## **Proposal for Supplement 4 to the 03 and Supplement 1 the 04 Series of Amendments of UN Regulation No. 100 (Electric power-train vehicles)**

### **Submitted by the experts from the International Association of the Body and Trailer Building Industry (CLCCR)**

Figure 1  
**Schematic to Measure Wrap-Around Distance**

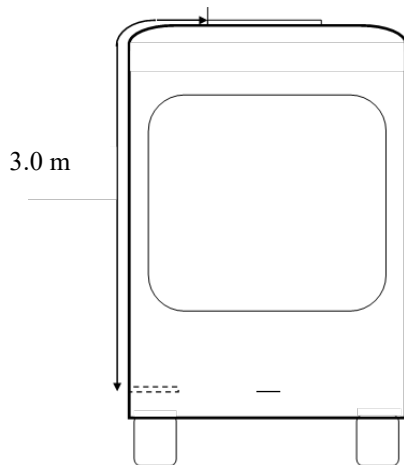
For vehicles of categories N<sub>2</sub>, N<sub>3</sub>, M<sub>2</sub>, ~~and~~ M<sub>3</sub>, **O<sub>3</sub> and O<sub>4</sub>**, conductive connection devices not energized except during charging of the REESS are exempted from this requirement if located on the roof of the vehicle out of reach for a person standing outside of the vehicle and, for vehicles of category M<sub>2</sub> and M<sub>3</sub>, the minimum wrap around distance from the instep of the vehicle to the roof mounted charging devices is 3 m. In case of multiple steps due to an elevated floor inside the vehicle, the wrap around distance is measured from the bottom most step at entry, as illustrated in Figure 1."

Figure 1  
 Generic description of test pulses

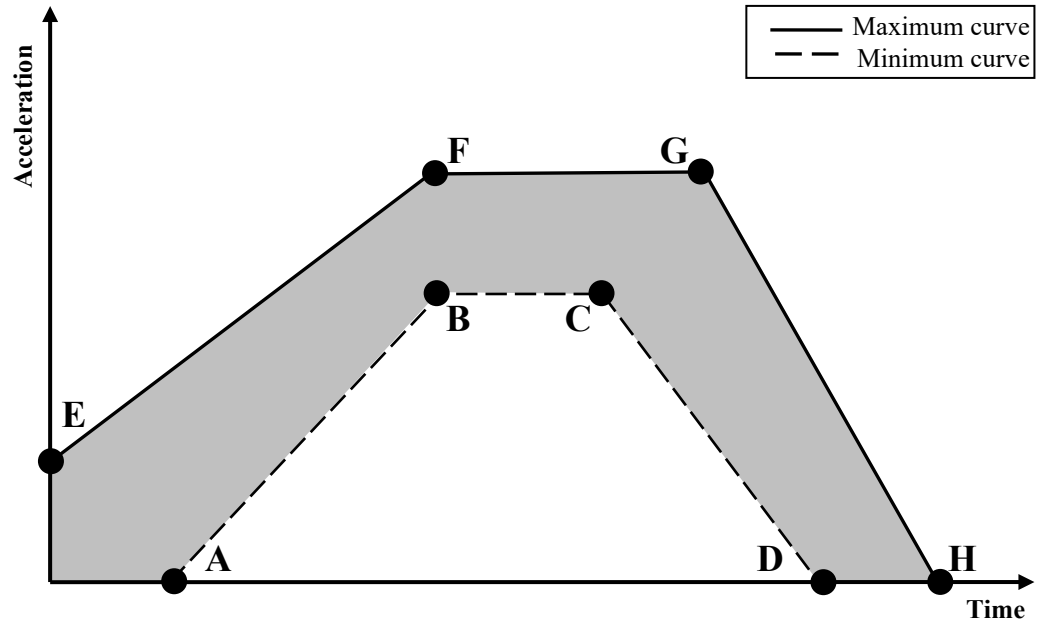
Table 1 for M<sub>1</sub>, and N<sub>1</sub>, O<sub>1</sub> and O<sub>2</sub> vehicles<sup>1</sup>:

Table 3 for M<sub>3</sub>, and N<sub>3</sub>, O<sub>3</sub>, O<sub>4</sub> vehicles:

- 1** For vehicles of category O<sub>1</sub> and O<sub>2</sub> at the request of the manufacturer the pulses defined in table 2 of Annex 9C paragraph 3.2 may be used if the maximum design speed of these vehicles of category O<sub>1</sub> and O<sub>2</sub> is limited to 100 km/h.

The resistance against mechanical shock is focusing on pulses of crash tests or similar performance tests of vehicles of category N1, N2, N3, M1, M2 and M3. Trailers are normally not in the scope of crash test regulations due to missing passengers. Therefore, it is recommended to define the performance pulses for trailers in relation to the category of the trailer and its real use-case.

REESS on O1/O2 may be tested with the pulse as defined for M1/N1 (Table 1), because they are the most common towing vehicles. Nevertheless, with few exceptions, the speed limits worldwide are lower for the combination of towing vehicle and trailer than those for the M1/N1 vehicles alone. Furthermore, the actual deceleration of a REESS into a trailer is lower than on a motorized vehicle because it is somehow mitigated, in the event of a crash, by the presence of the towing vehicle itself. Therefore, an option should be given to the manufacturers of O1/O2 to test their REESS according to the specifications provided for M2/N2 (Table 2), if their design speed is limited to 100 km/h.

REESS for O3/O4 may be tested with a pulse related to requirements for N3/M3, again because they are their most common towing vehicles.
